Development Review Division

TO: Casey Adragna, Adragna Architecture
FROM: Elizabeth Steward, Associate Planner- Development Review
DATE: 10/27/25
SUBJECT: Douglas 234 Multitenant, Site Plan
Review Comments 02

SITE PLAN
HORSE CREEK COMMERCIAL
 LOT 10B, DOUGLAS 234 FILING NO. 6, AMENDMENT 2
 A PORTION OF THE SW 1/4, SE 1/4, SECTION 29, T6S, R66W, 6TH P.M.
 TOWN OF PARKER, COUNTY OF DOUGLAS, STATE OF COLORADO

LANDSCAPE PLAN
DOUGAS 234 FILING NO. 6, AMD. 2
DATE: OCTOBER 2, 2025
SHEET _ OF _

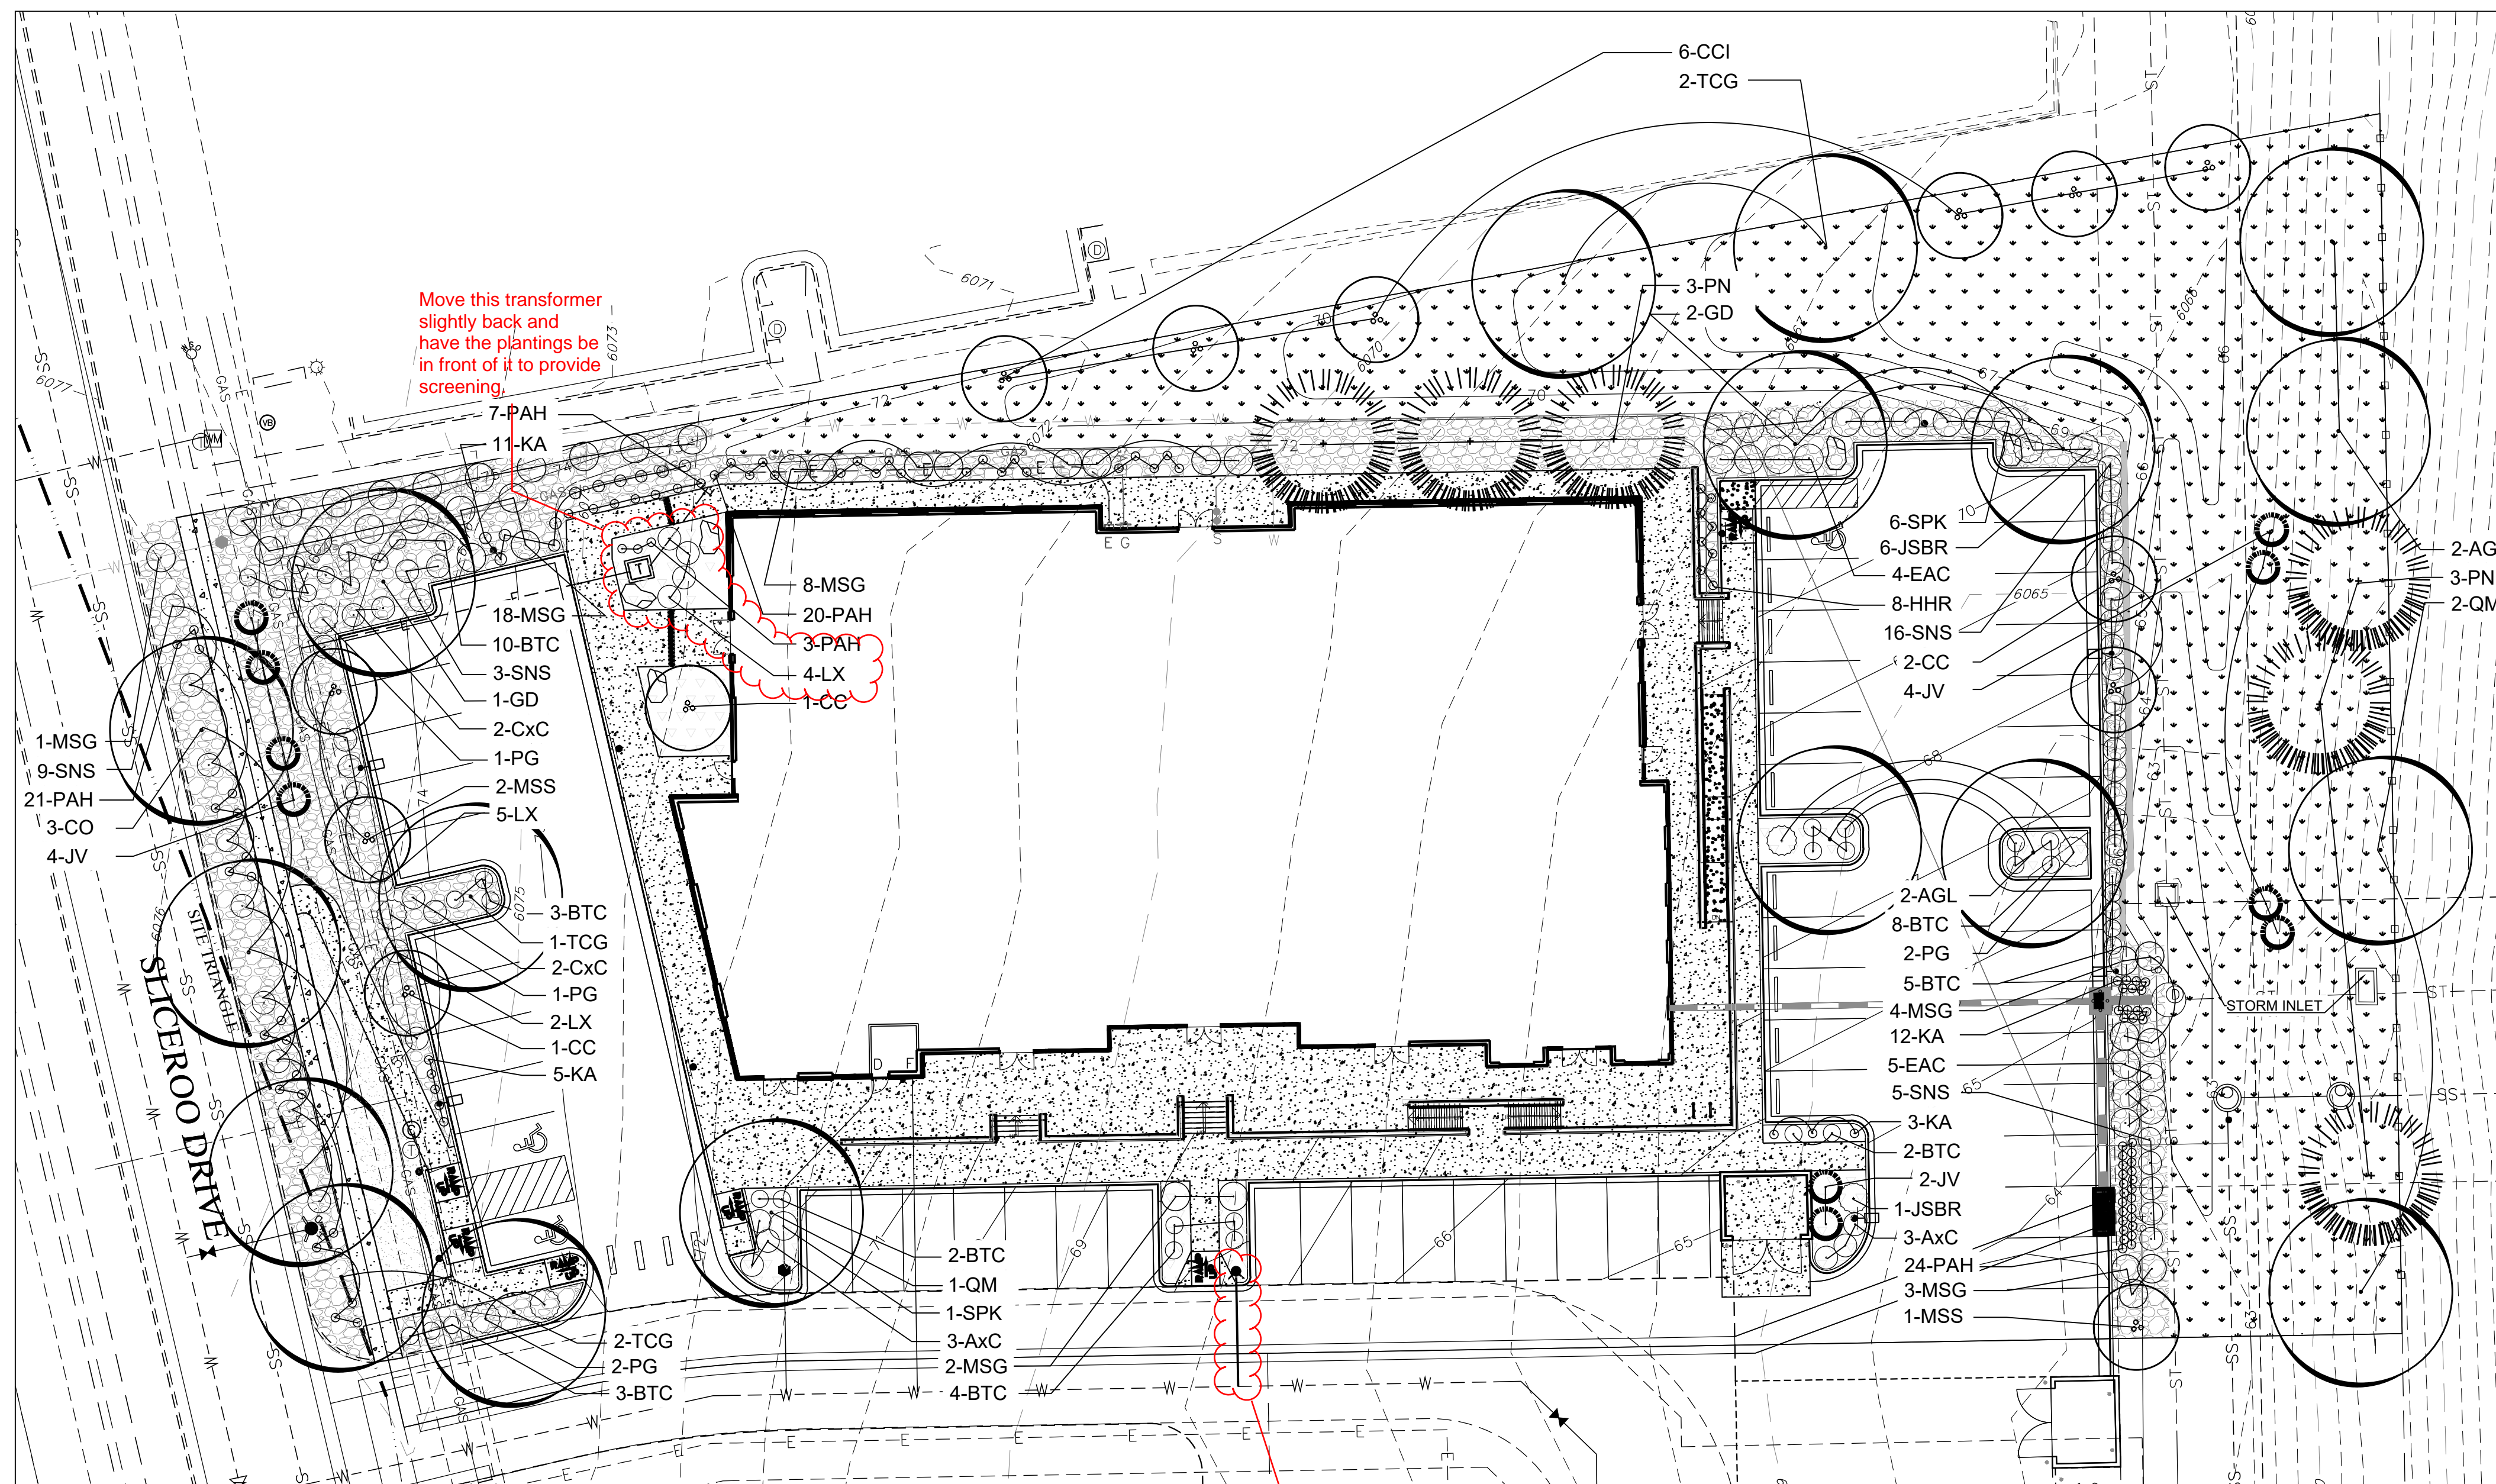
The parking lot table needs to break out each island separately

plant schedule shows 45 trees

plant schedule shows 120

SITE PHOTOMETRIC PLAN
 DOUGLAS 234 FILING NO. 6, AMD. 2
 DATE: OCTOBER 2, 2025
 SHEET LT1

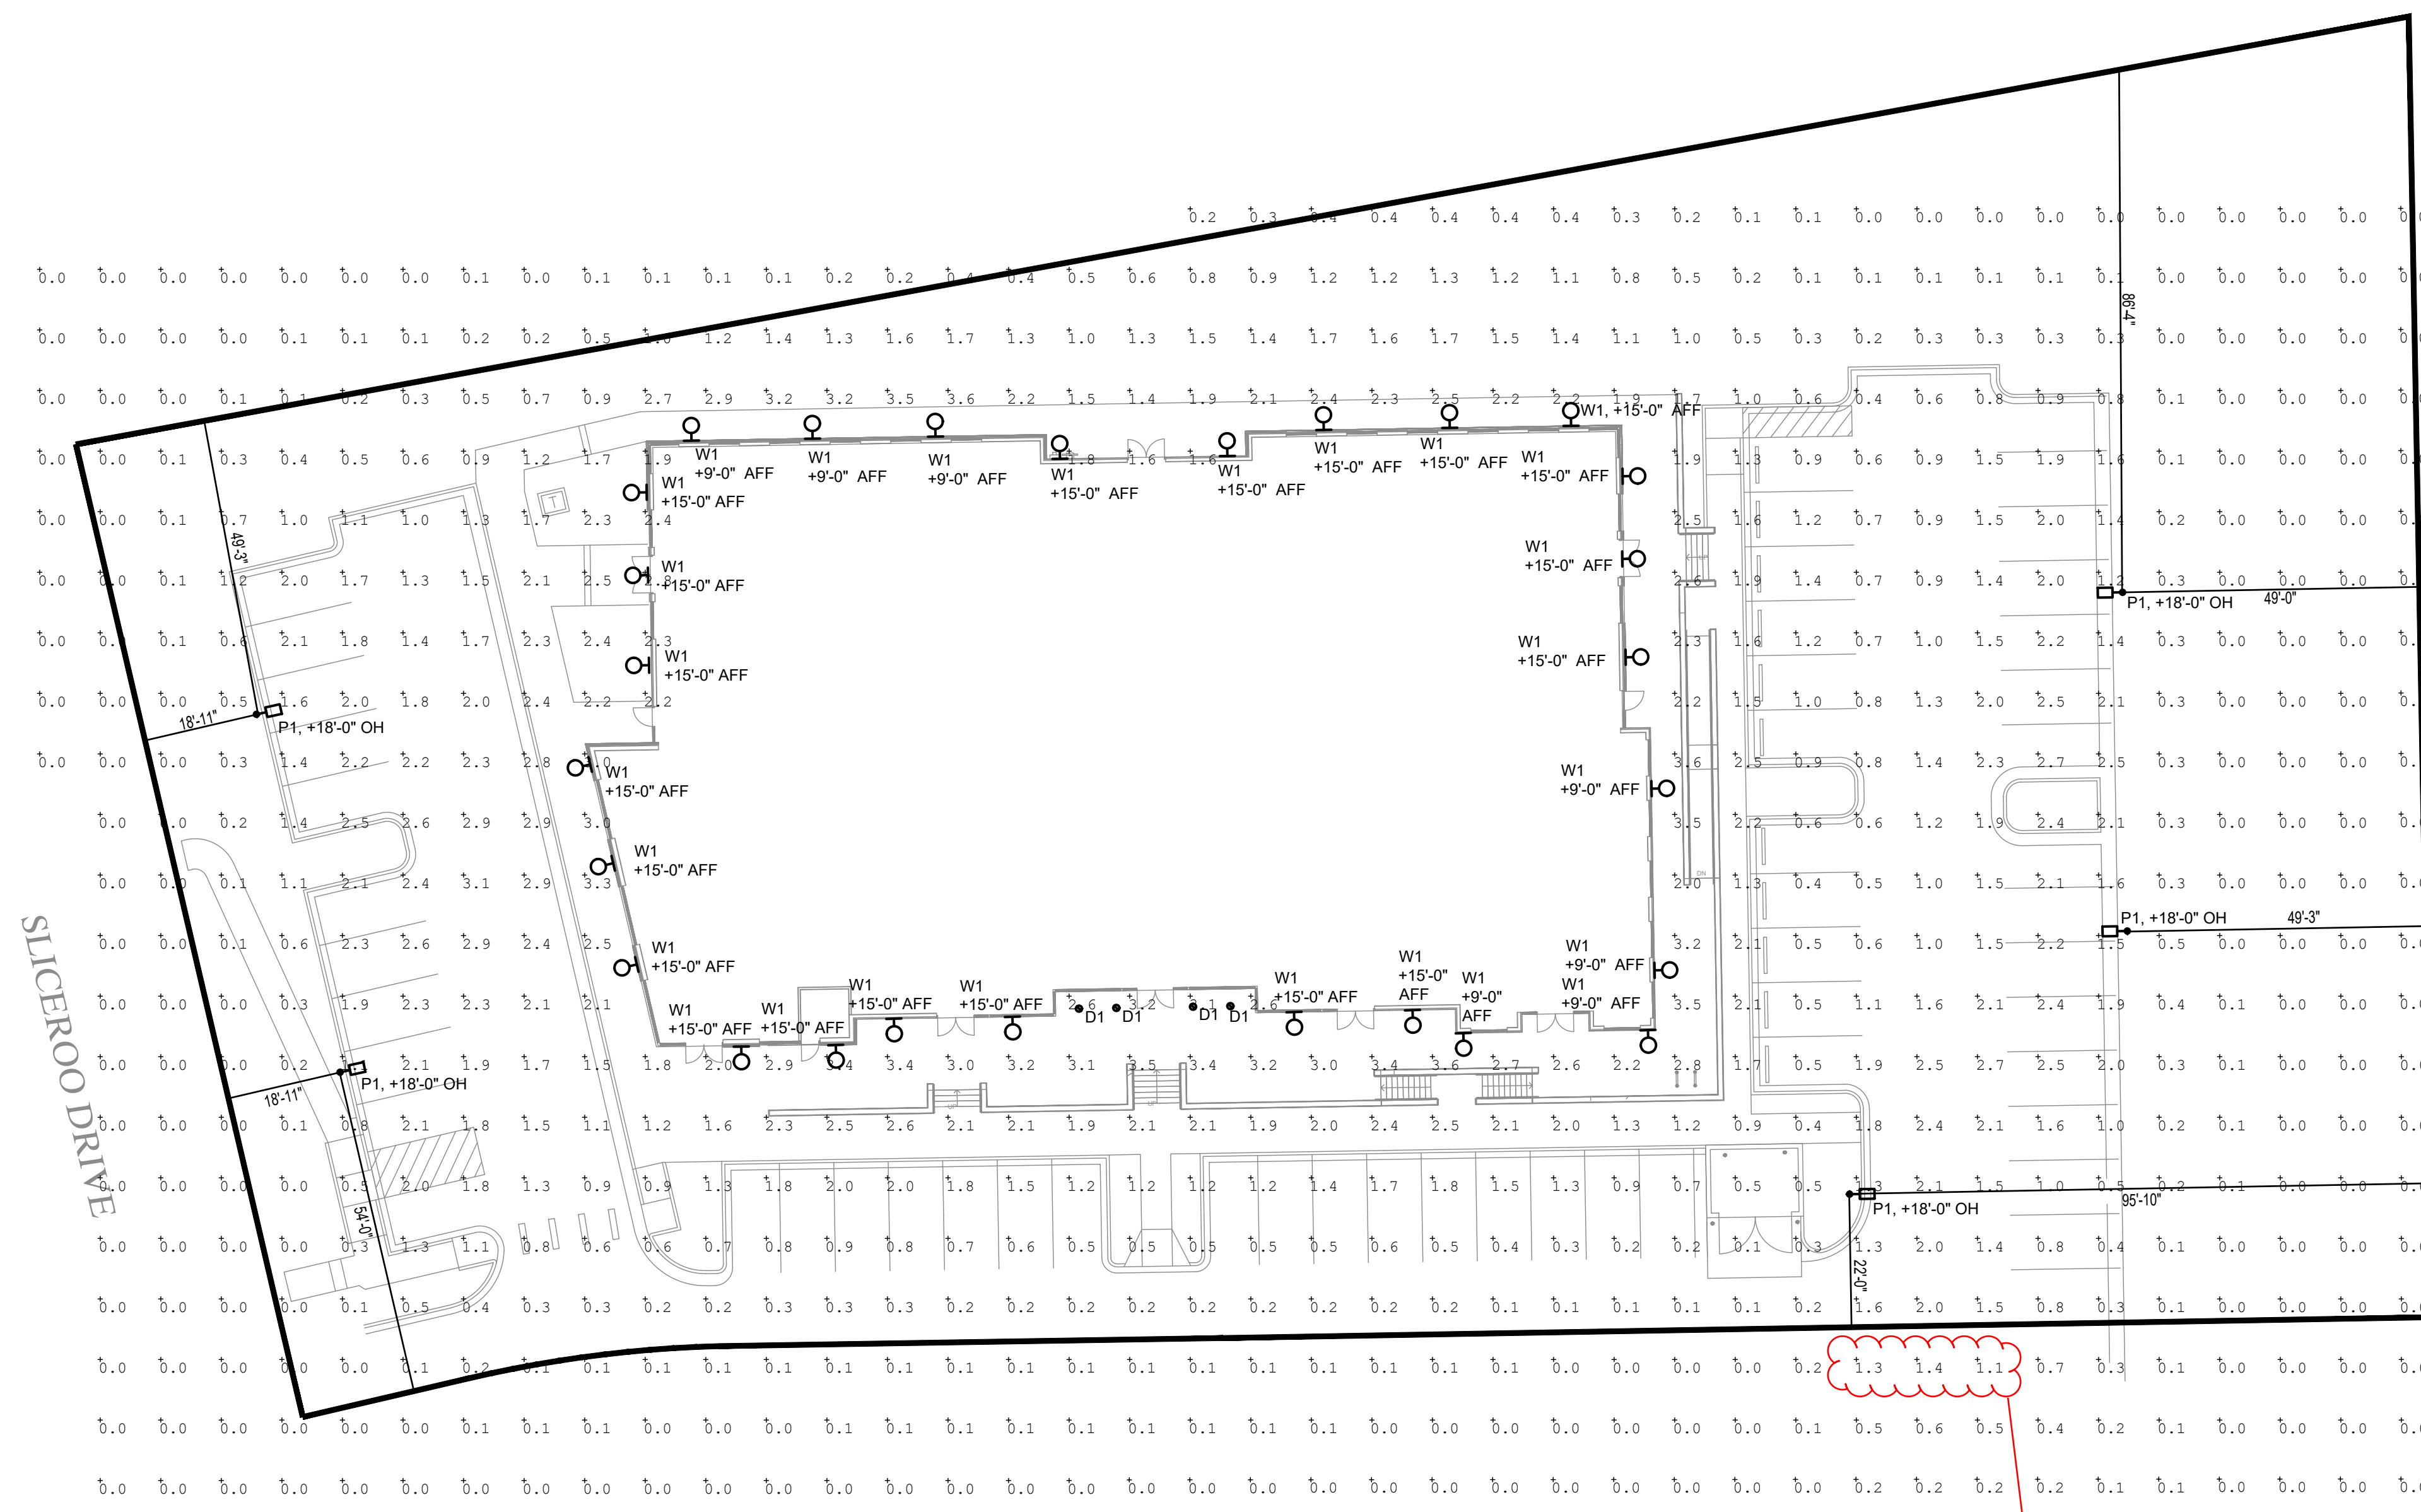
maximum height of mounted lighting is 15ft, please ensure this is below this, add label of height of mounting.
